# MEMORANDUM

**SUBJECT:** East Grand Avenue Overlay District Zoning Study – Public Testimony and Revised Proposed Amendments

**TO:** Planning Commission

**FROM:** Comprehensive and Neighborhood Planning Committee

**IMAGE A**

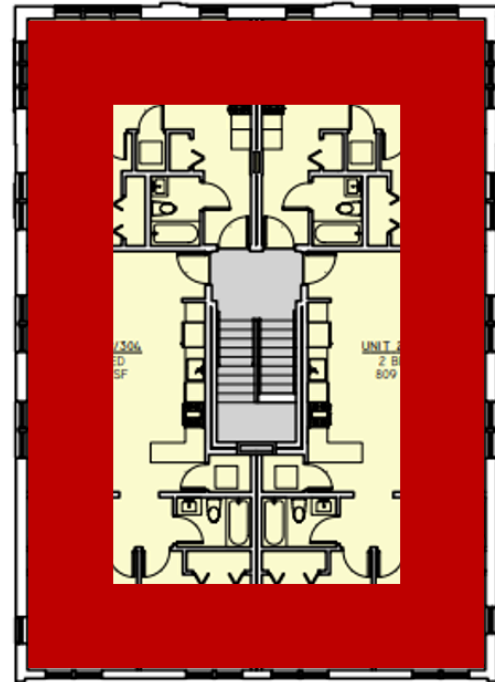
Take a 3-story development on a 65' wide lot as an example. Without setbacks, the building pictured below could contain ~12 residential units. Given current land, construction and financing conditions, the project below – recently built in Minneapolis by a small-scale local developer – could be economically unviable.

**IMAGE B-** (2x) 2-bed & (2x) 1-bed units

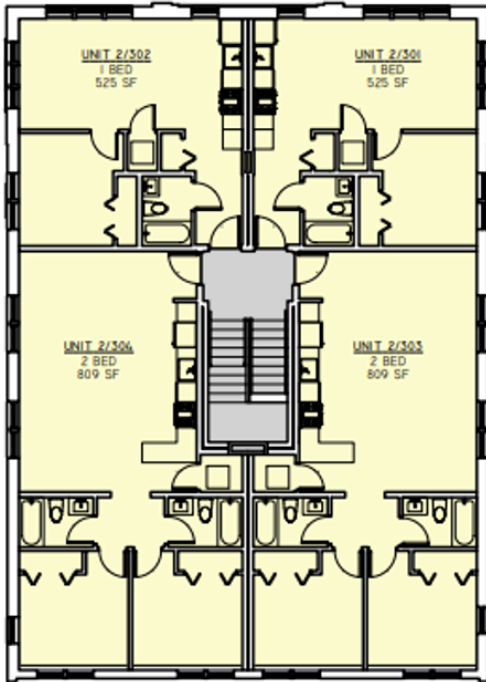
**Image B** on the left below shows the 3rd floor of the building without stepbacks includes two 2-bed units and two 1-bed units . **Image C** on the right shows the stepbacks as proposed would result in the loss of >50% of the built square footage and two 2-bed units. **Under these conditions, no project would be built.**

In a development with the stepbacks pictured on the right:

- The cost of land, design, utilities, fire protection and facade would stay the same
- The cost of framing would increase with added complexity
- The rent generated by the project, which is required by lenders and investors, would decline due to the loss of multiple units

*\* 800 Grand Ave, 3 stories (0 setback from both)*

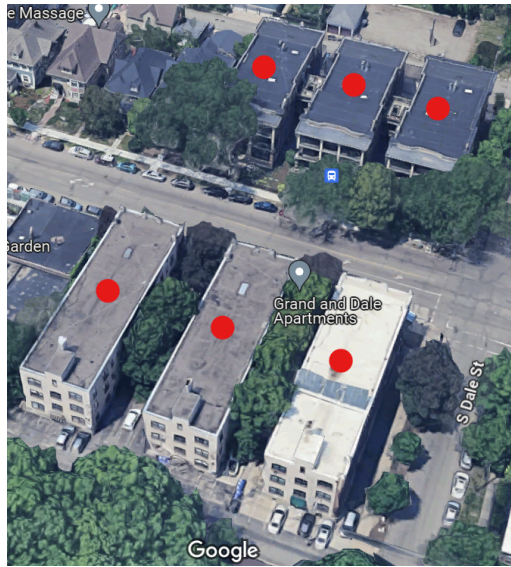
**Appendix: Examples of existing Grand Avenue buildings east of Virginia that would be prohibited to build under the current proposed overlay district**

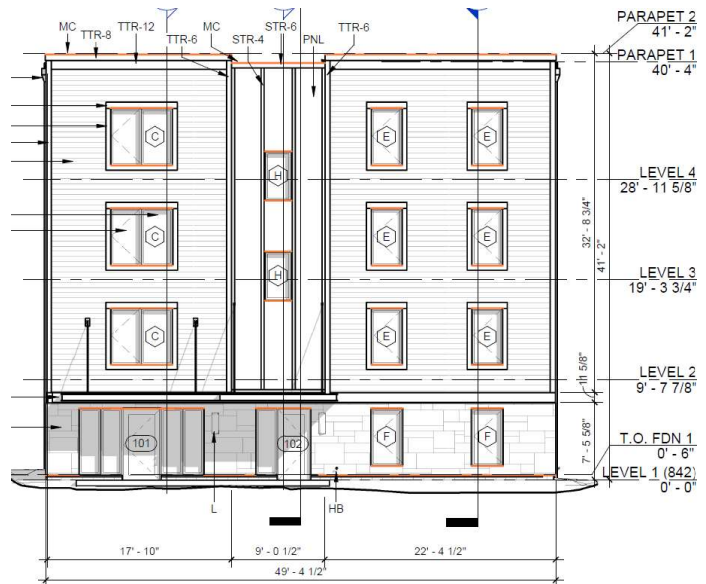
At 41' tall, this is abnormally short for a 4-story building. Each floor has only 8' ceilings, and thinner trusses were used between floors (**at great additional expense**) to shorten the building height.

**Buildings with ground floor commercial**, like we want on Grand Avenue, are **universally taller**. In a more typical building, the **step back would therefore occur starting on the 2nd floor...exacerbating the impacts illustrated below.**

Image #3 below shows the current stepback proposal of 10' on all sides of the building. The 4th floor is mostly hallway & stairs, with poorly functioning, bowling-alley shaped units. In this scenario, no 4th floor would be attempted. **With only 3 stories of units, and the high cost of land on Grand Avenue, the project would be economically inviable. No bank or investors would fund it.**

In Image #2, we see that having a 10' step back on just the front yard of the building would **eliminate 2 entire homes**. The loss of these units still **make the project economically inviable.**
